HISTORIC AND DESIGN REVIEW COMMISSION January 17, 2018

HDRC CASE NO: 2018-023
ADDRESS: 121 BUFORD

TYPE OF WORK: Installation of front yard fencing, exterior modifications, skirting modifications,

porch column modifications, demolition of original chimney, addition amendments

HDRC APPROVED DESIGN - MARCH 1, 2017. PROPOSED SITE

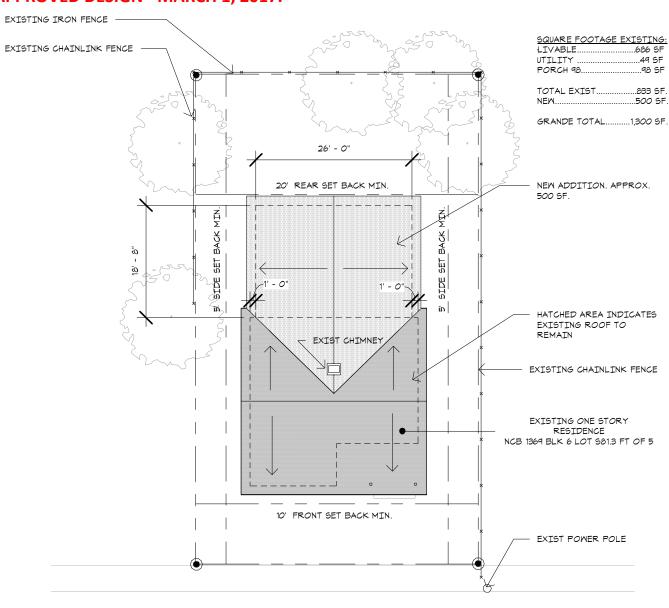
- j. FENCING –The applicant has proposed front yard fencing prior to receiving a Certificate of Appropriateness. The front yard fence features four by four wood fence posts with wide horizontal pickets. This is not an appropriate front yard fence for the Dignowity Hill Historic District. Staff finds that the fence should be removed.

- g. WALKWAY The applicant has installed a front yard walkway consisting of decomposed granite and concrete pavers. The historic pattern on Buford as well as throughout the Dinowity Hill Historic District is for the installation of concrete walkways. A photo from March 2011 notes the original front walkway of concrete. Staff does not find the installed walkway to be appropriate or consistent with the Guidelines for Site ELEMENTS 5.a.ii.

- 3. Staff does not recommend approval of item #3, the front yard fence based on finding j. Staff recommends that the fence be removed. The applicant may return to the HDRC with an appropriate fencing proposal.

- 4. Staff does not recommend approval of item #4, the front yard sidewalk based on finding g. Staff recommends the decomposed granite and concrete paver walkway be replaced with a concrete walkway not to exceed three feet in width based on finding h.

PROPOSED ELEVATIONS

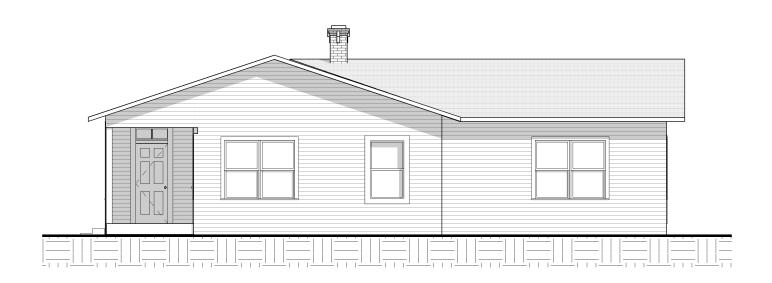
- d. REAR ADDITION The rear addition was constructed inconsistently with the previously approved design. Window and door openings, roof form, a side deck and door canopy and siding installation have been identified as being inconsistent with the previously approved design.

- e. REAR ADDITION Staff generally finds the constructed window and door openings to be appropriate as well as the constructed roof form. On the east façade of the addition, the applicant has constructed a side porch deck and door canopy, neither of which was included in the previously approved design. Generally, staff finds these installations appropriate; however, the applicant has installed a metal foundation skirting. Staff finds that the side deck should feature wood or Hardi skirting. Metal foundation skirting is not an appropriate foundation skirting material for the Dignowity Hill Historic District.

- f. REAR ADDITION SIDING The previously approved construction documents noted the rear addition featuring wood siding to match the profile of that of the primary historic structure. The applicant has installed wood siding that features an exposure that is nearly triple that of the primary historic structure's siding. Staff finds this inappropriate.

- 2. Staff recommends approval of item #2, amendments to the rear addition, based on findings d through f with the following stipulations:
 - i. That wood or Hardi foundation skirting be installed on the side deck.

- ii. That the installed HVAC unit be screened with shrubbery or another screening element.
 - iii. That wood siding that matches the profile of that found on the historic structure is installed.
